APPROVED
Limited building only review
Permit holder responsible for full compliance with the code

**WEST PRESERVE
LOT - 4
TBD THISTLE COURT
SANFORD, NC 27332
3 CAR GARAGE**

FRONT & REAR ELEVATIONS
THE GASTON II

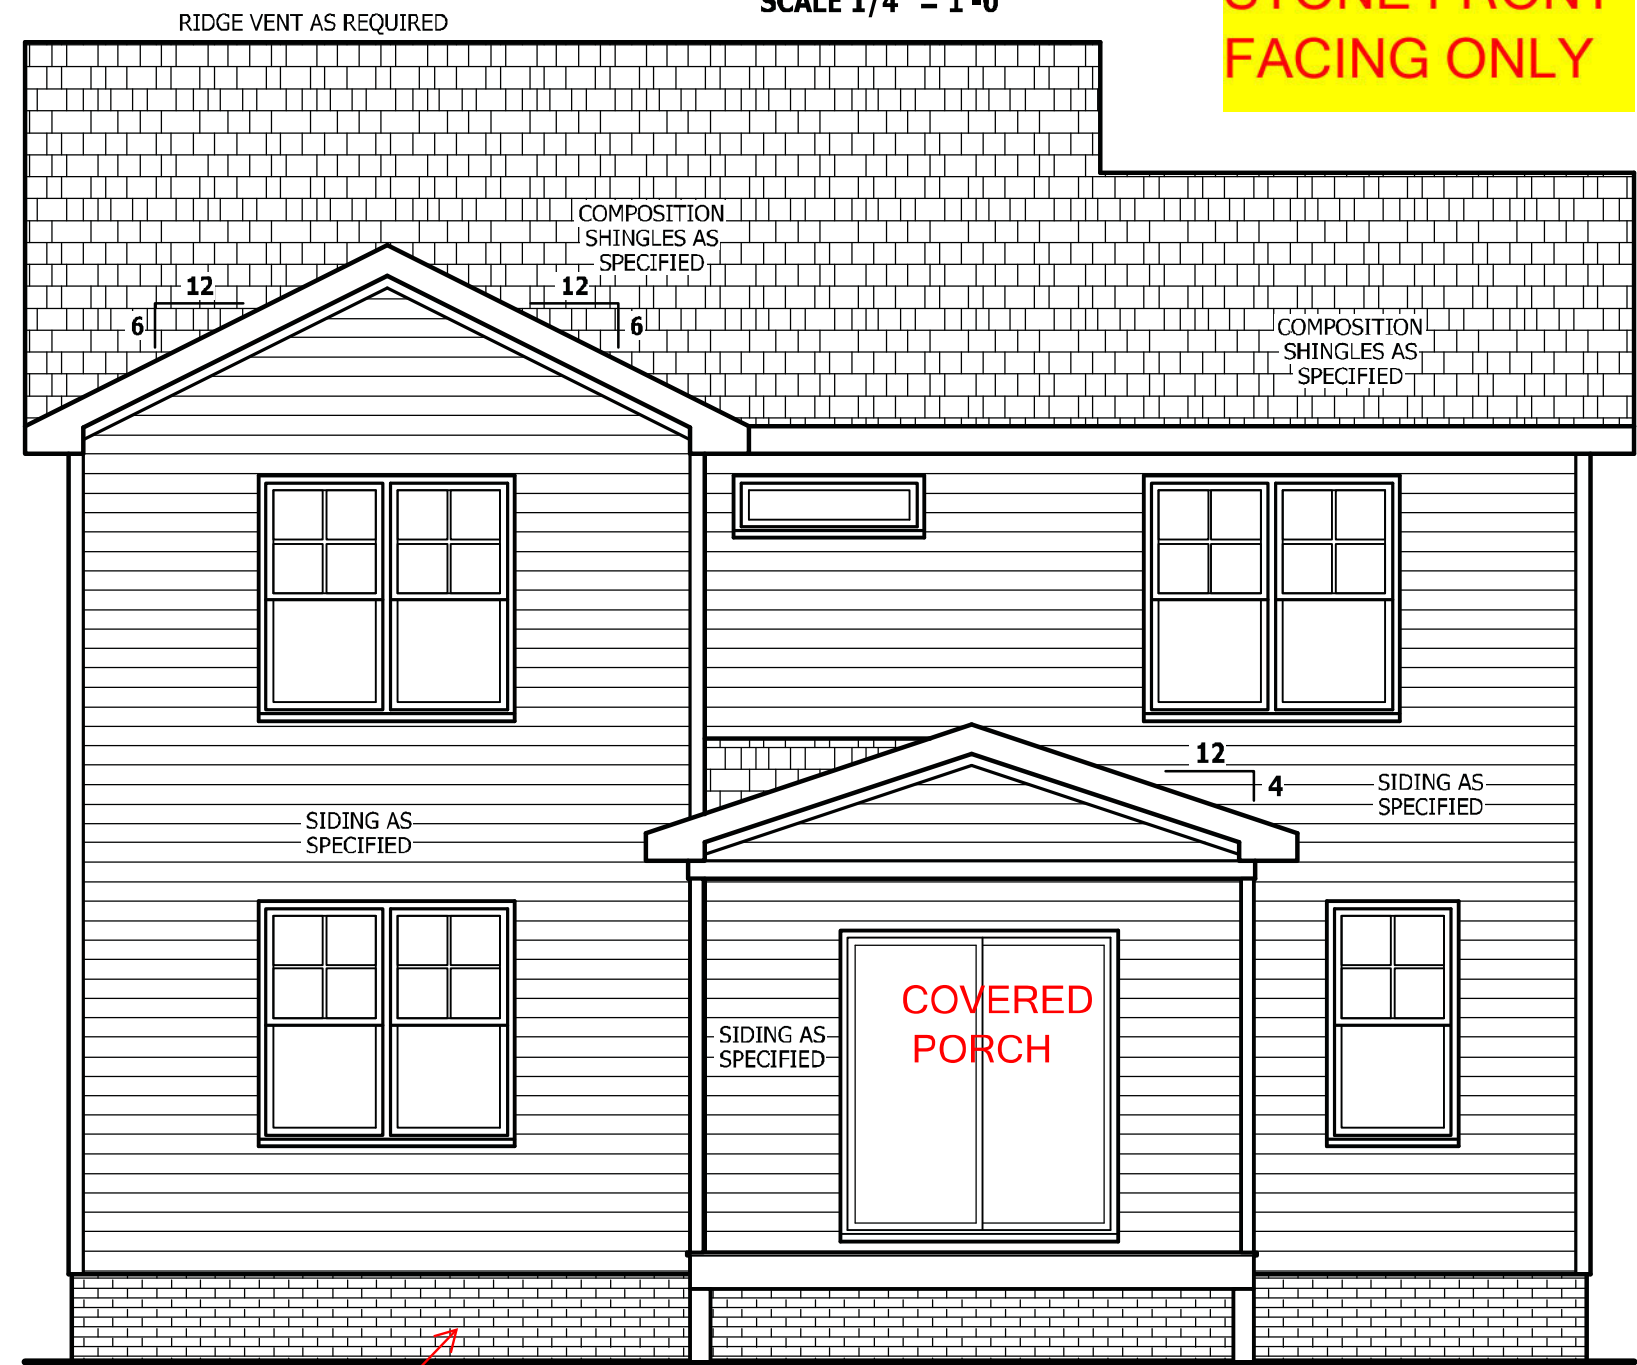
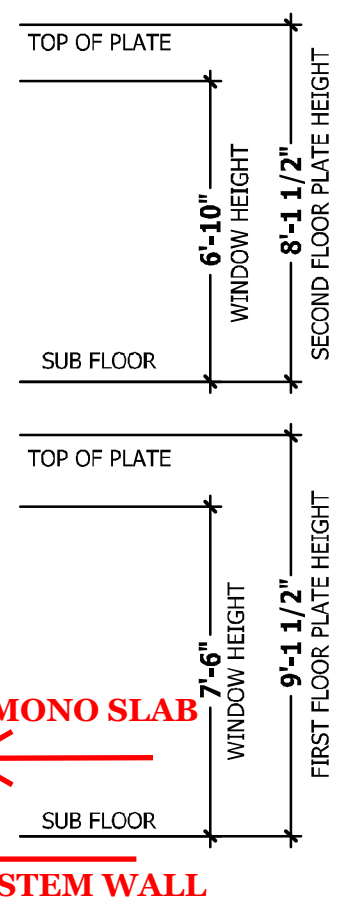
NOTE:
MONO SLAB - STONE TO RUN TO THE BOTTOM OF WINDOW
STEM WALL - STONE TO FOUNDATION HEIGHT ONLY
